3000 Series Zeus Pod – Gearcase Oil Drain Tube Seal Improvement

Models Covered
All Zeus 3000 Series Pods

a - Bronze split ring

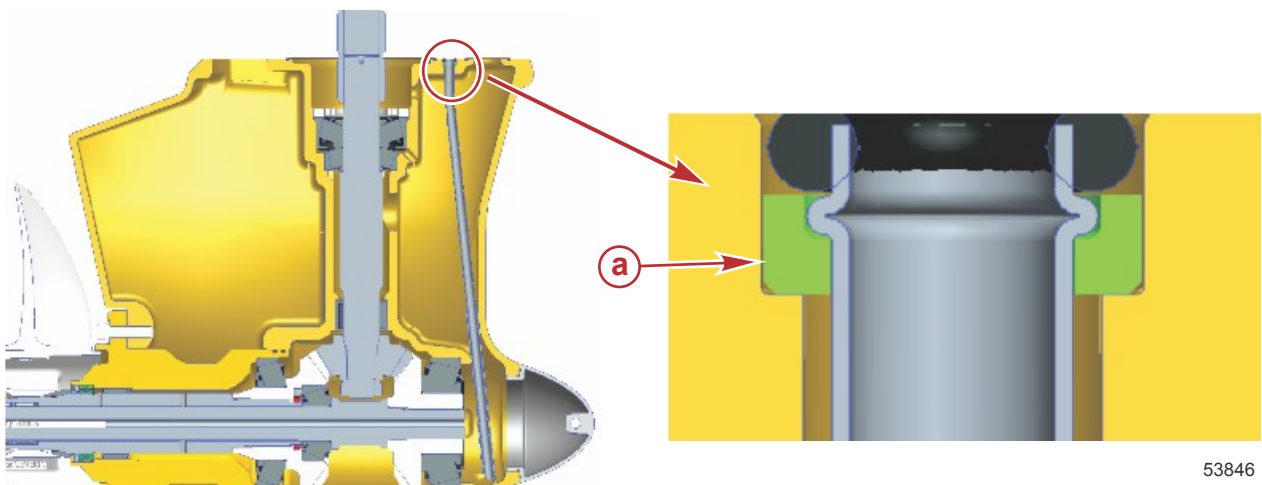
The drain tube seal design on the split-line surface of the gearcase housing has been improved. The former double O-ring design has been upgraded to include a new brass split ring in combination with the single O-ring. This split ring will maintain the drain tube in a consistent location and provide for reliable sealing of the O-ring between the gearcase and king pin adaptor plate mounting surfaces. Refer to the installation sketch below.

This new design was implemented for production Zeus pods starting with serial number 0M969929.

On product built prior to this serial number, and during a service event requiring the gearcase to be removed, this new split ring is available to be installed.
